8 March 2017

Our Ref: 16-147
Your Ref: MCUI2016/1591

RE: RESPONSE TO COUNCILS INFORMATION REQUEST UNDER S278 OF THE SUSTAINABLE PLANNING ACT ASSOCIATED WITH A PROPOSED 'CARAVAN PARK' OVER LOT 45 ON SR835 AT LOT 45 CAPTAIN COOK HIGHWAY, PORT DOUGLAS.

PROPOSED SITE PLAN
SCALE
1:1000 @ A1
1:2000 @ A3

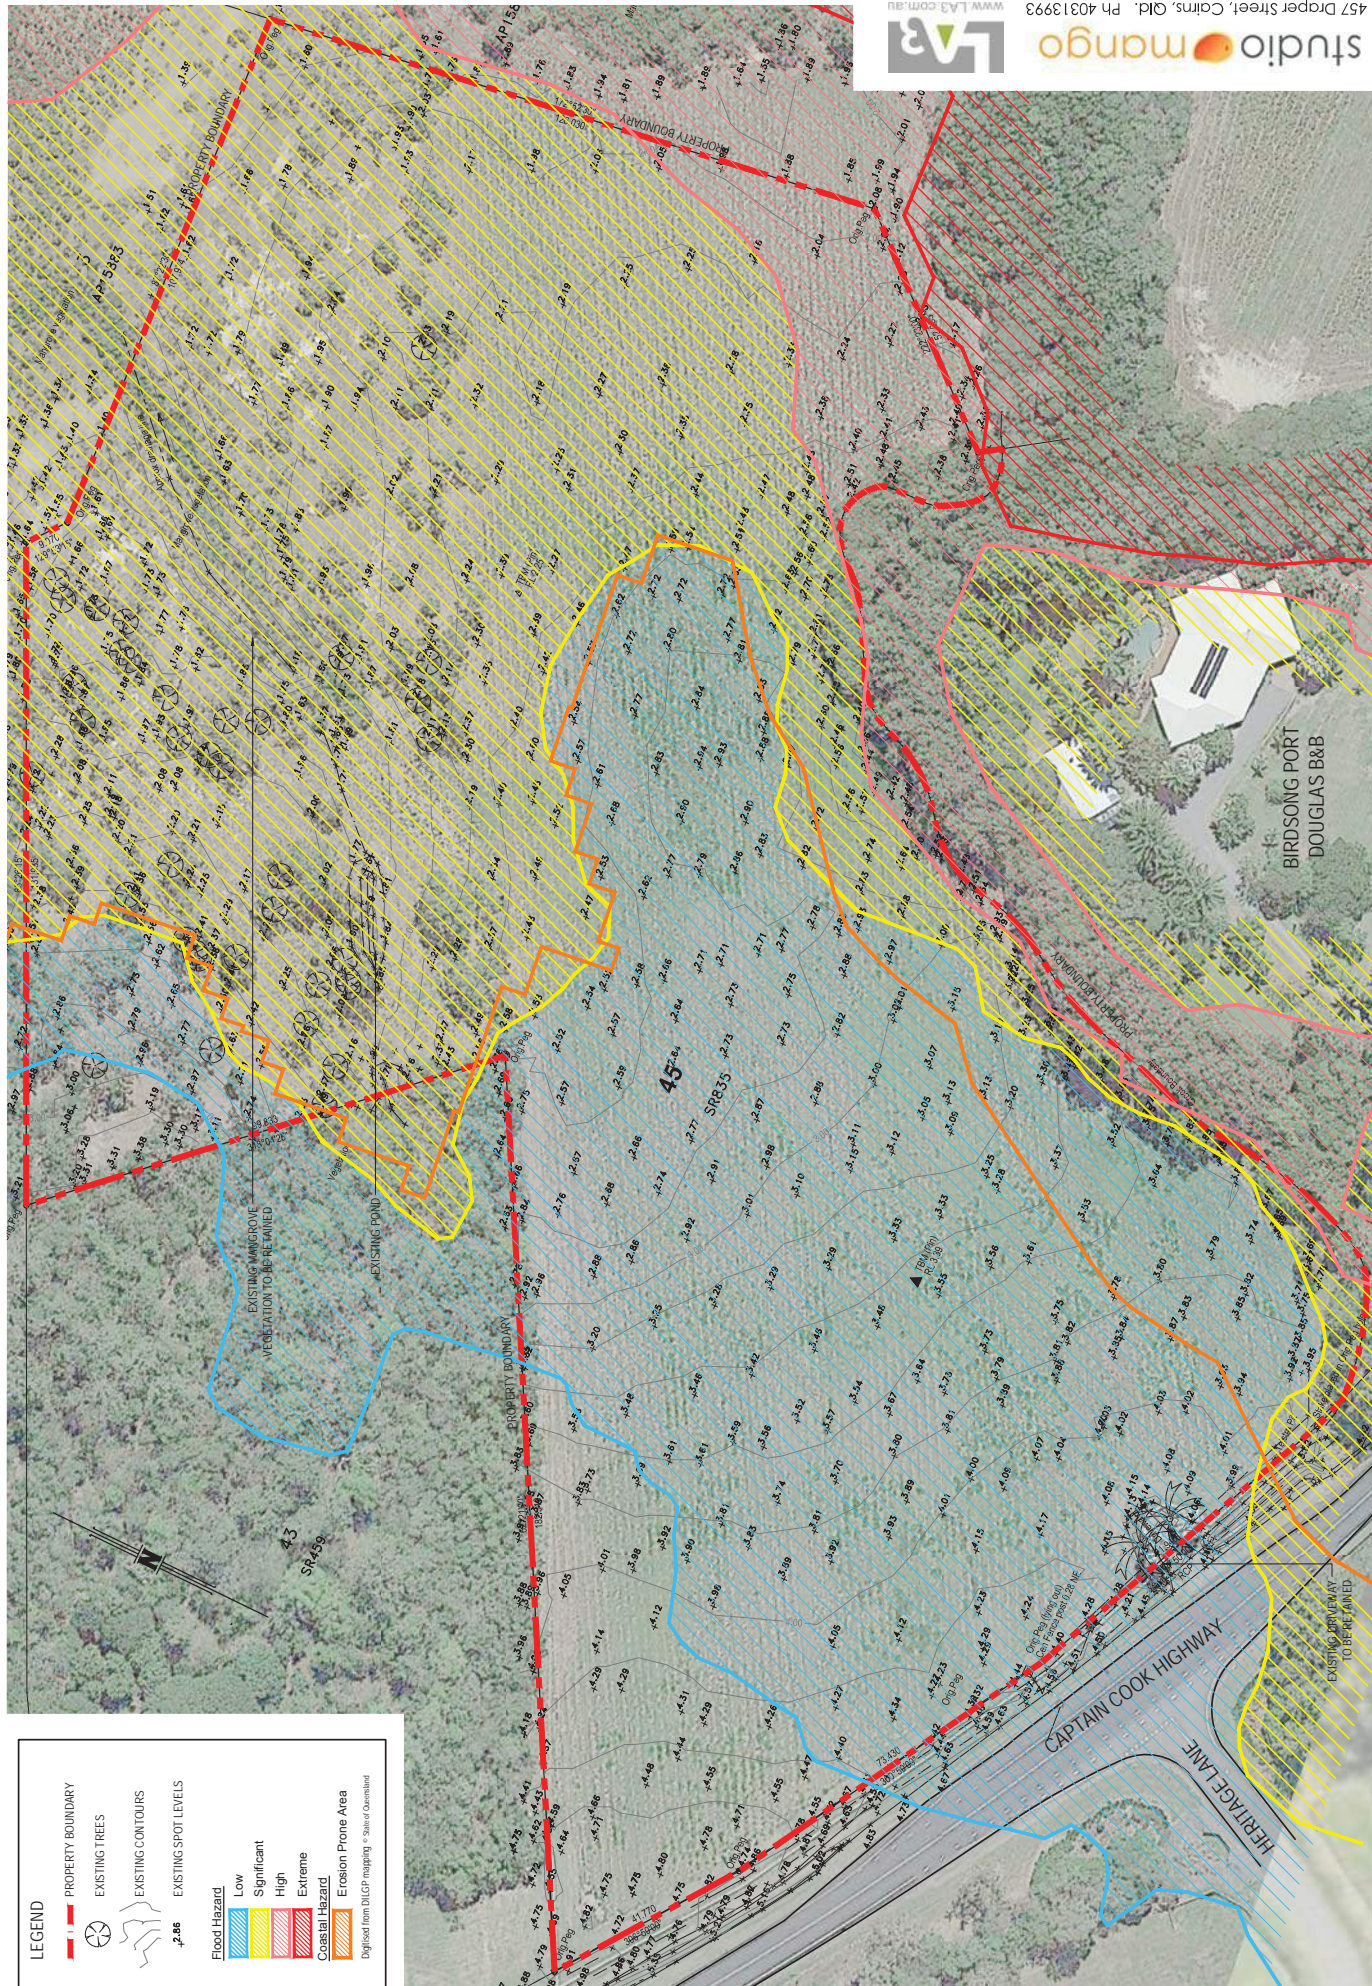
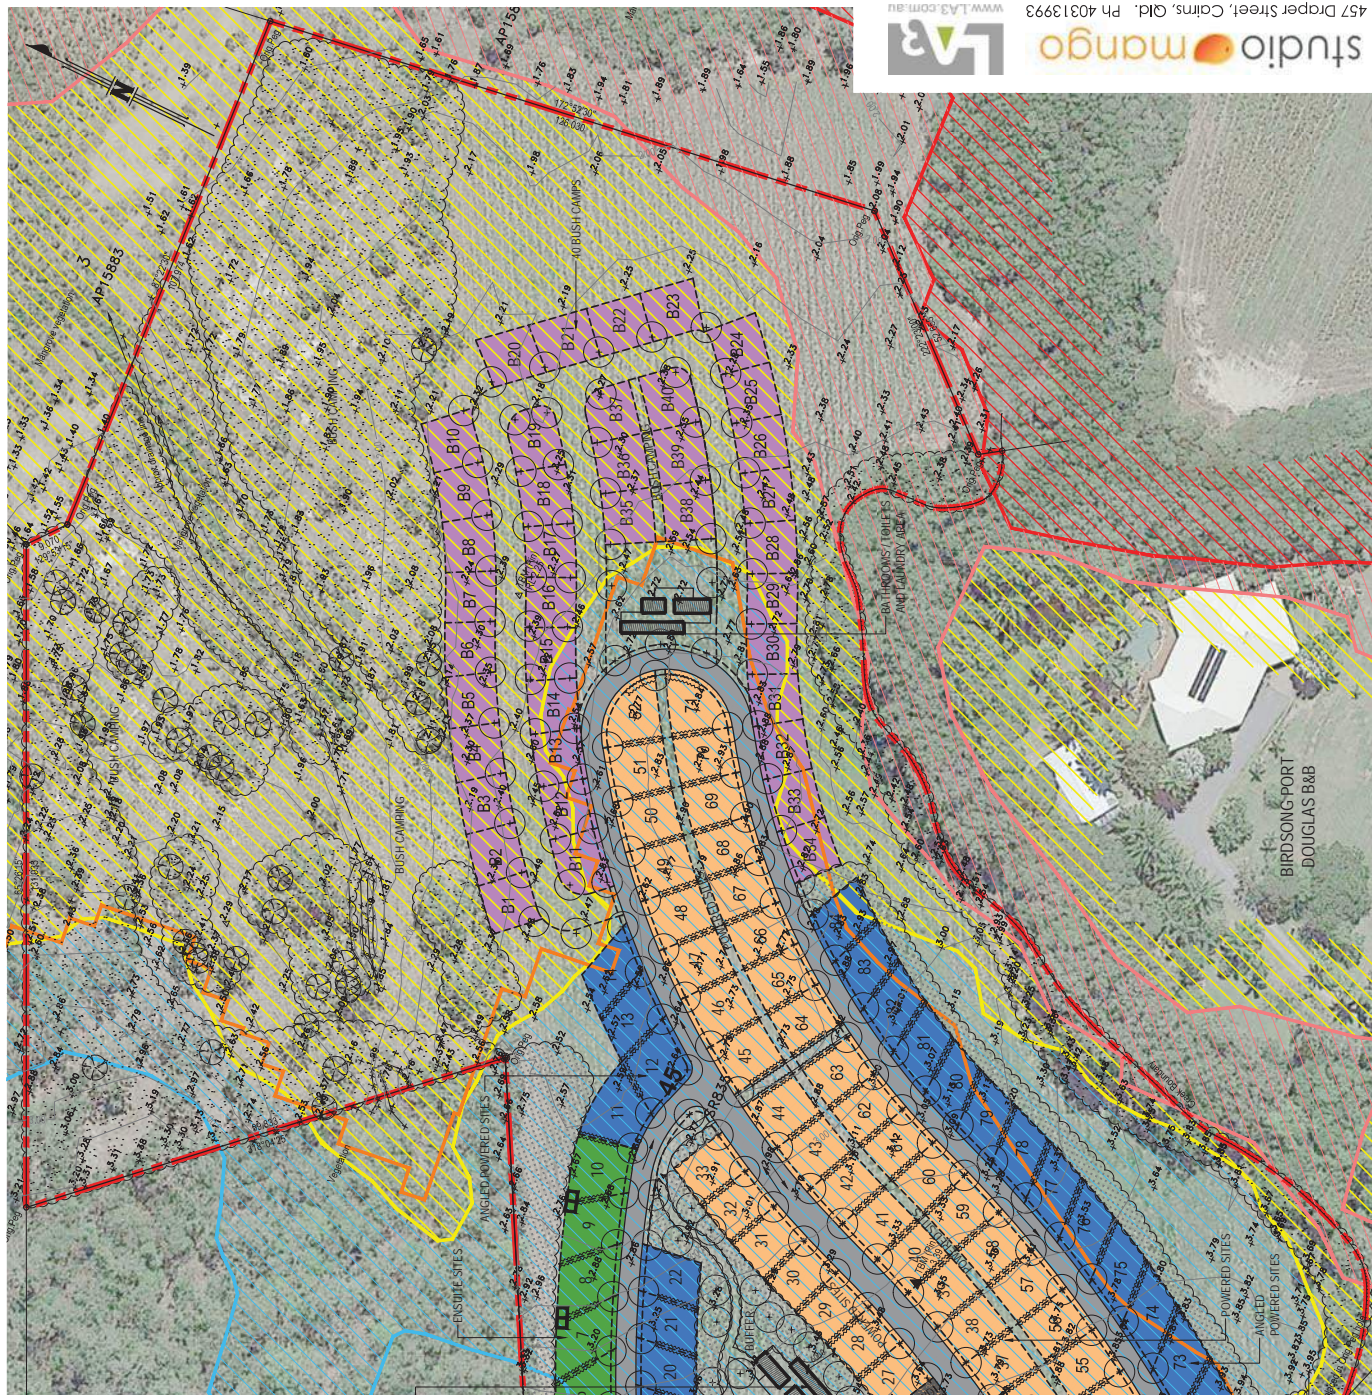
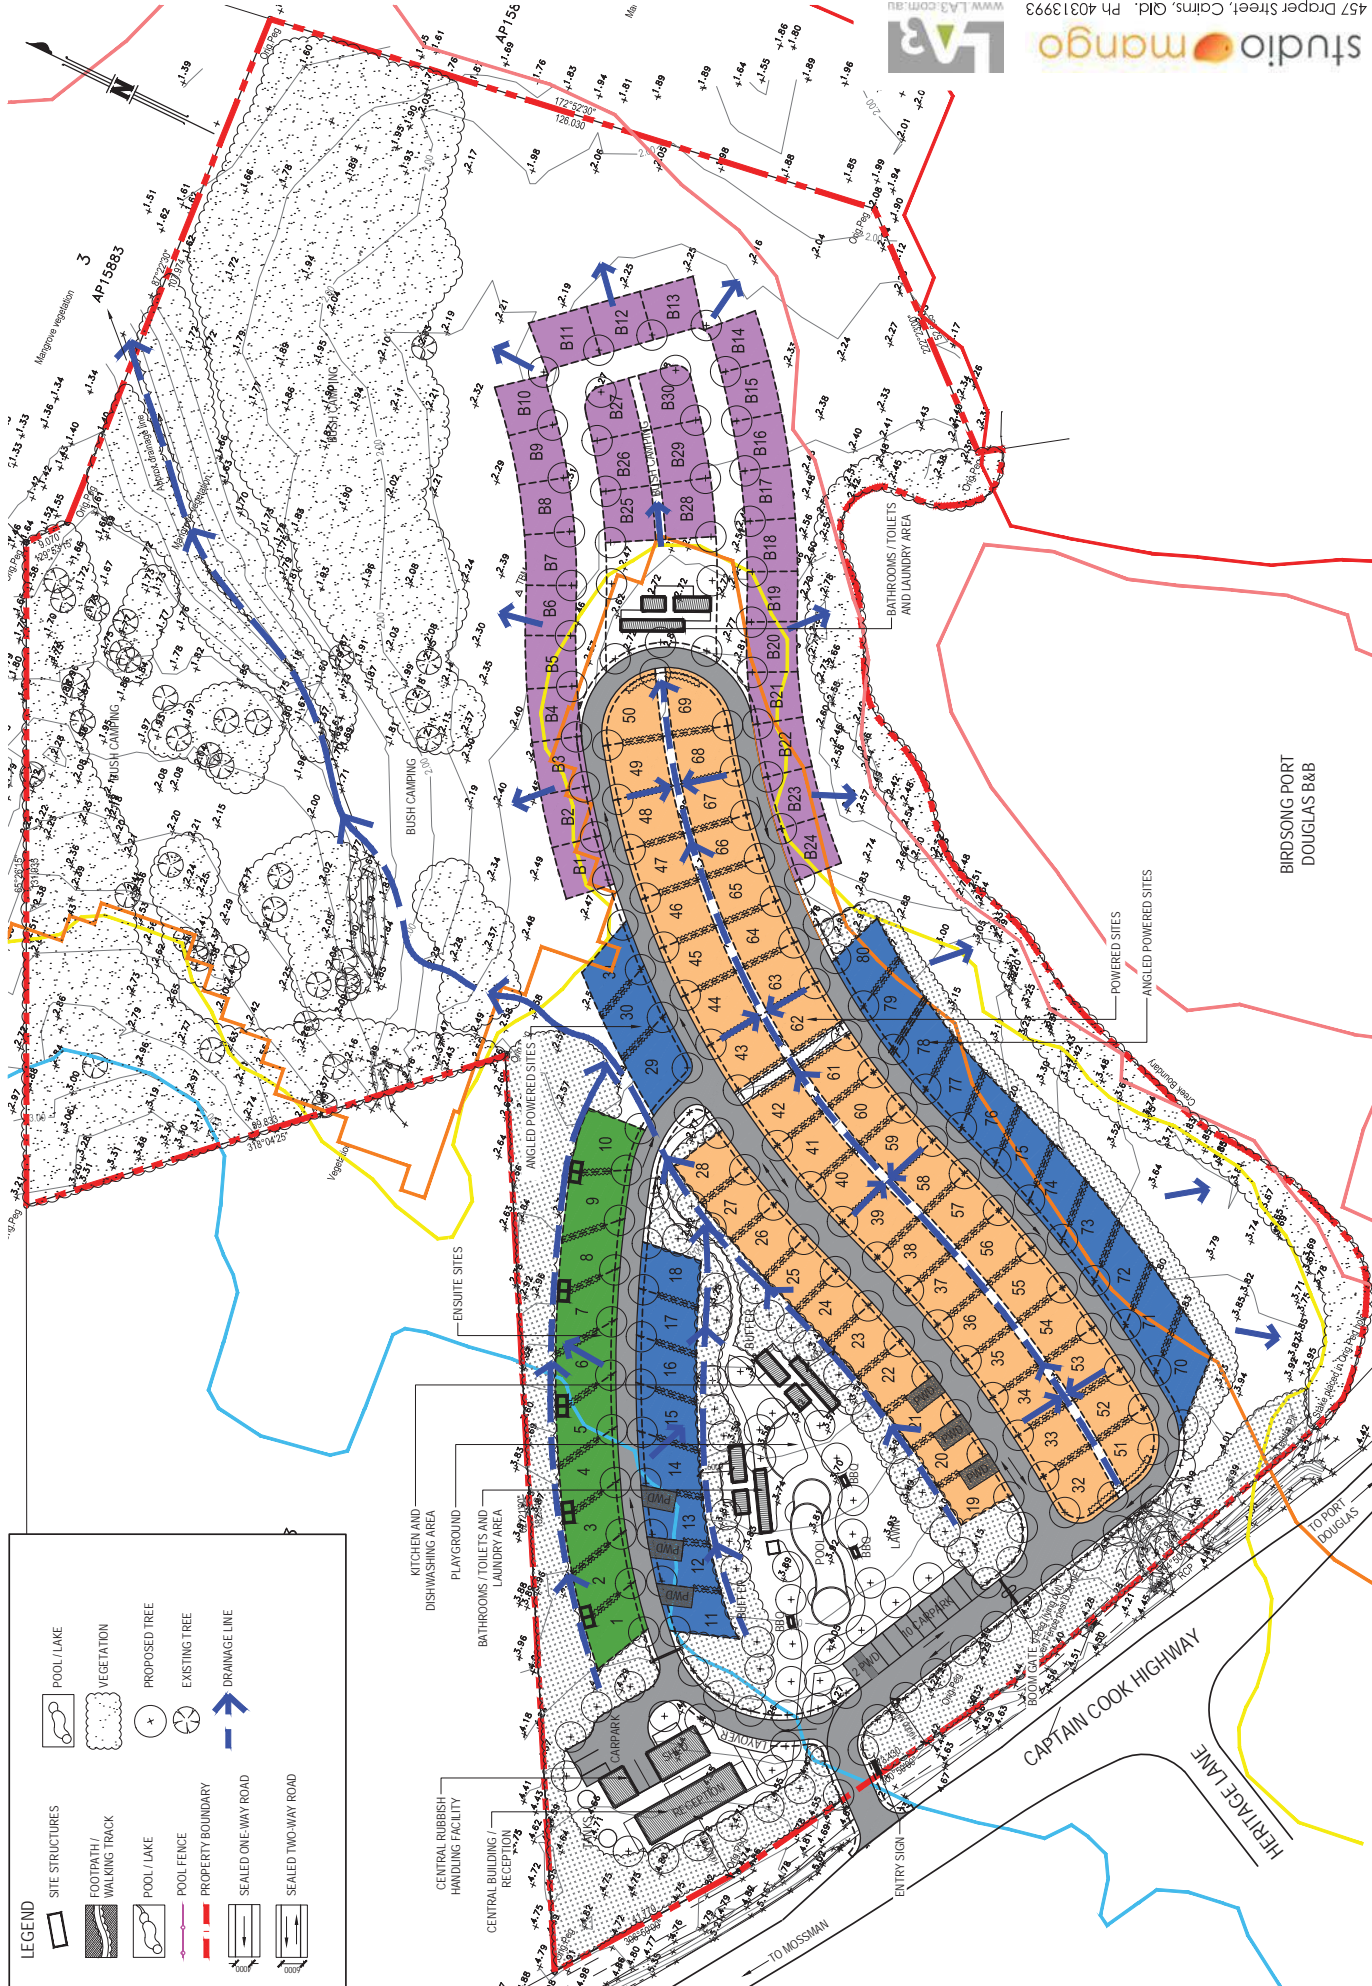
In response to Council's Information Request and the outcomes of a meeting held between the Applicants, their representatives and Council on Thursday 22 September 2016 (see **Attachment 2**), a number of amendments to the originally submitted plan of development have been made. These changes have focused on reverting the proposed development back to a configuration that is closer to that given 'in principle' support by Council during pre-lodgement discussions, as well as to remove the parts of the proposed development which were at high risk from natural hazards. The revised plan of development is included as **Attachment 3**, with the main changes to the plan being summarised below and include:

- Delineation of the 'low', 'significant', 'high', and 'extreme' hazard areas associated with a 1% Annual Exceedance Probability (AEP) flood event, as well as the erosion prone area, on the site;

- A reduction in the total number of sites from 150 to 124 and a significantly scaled back development footprint. This in turn, has also resulted in increased setbacks to the adjacent watercourse, remnant vegetation, the existing drainage gully and side and rear boundaries;

- Removal of all 'hard' infrastructure from the lower portions of the site which are subject to a 'significant' (or higher) flood hazard and/or that were previously located in the Erosion Prone Area (EPA);

- A reduction in the number of van sites from 94 to 84, inclusive of minor amendments to the layout to ensure all such sites are generally located clear of the portions of the site which are subject to a 'significant' (or higher) flood hazard and the EPA;

- Relocation of all ensuite sites to higher ground to ensure all associated infrastructure is located clear of the portions of the site which are subject to a 'significant' (or higher) flood hazard and/or the EPA (Note: to ensure full flood immunity, the infrastructure located on sites 7-10 may require further relocation i.e., to sites 15-18. This will however, be determined at Operational Works stage;
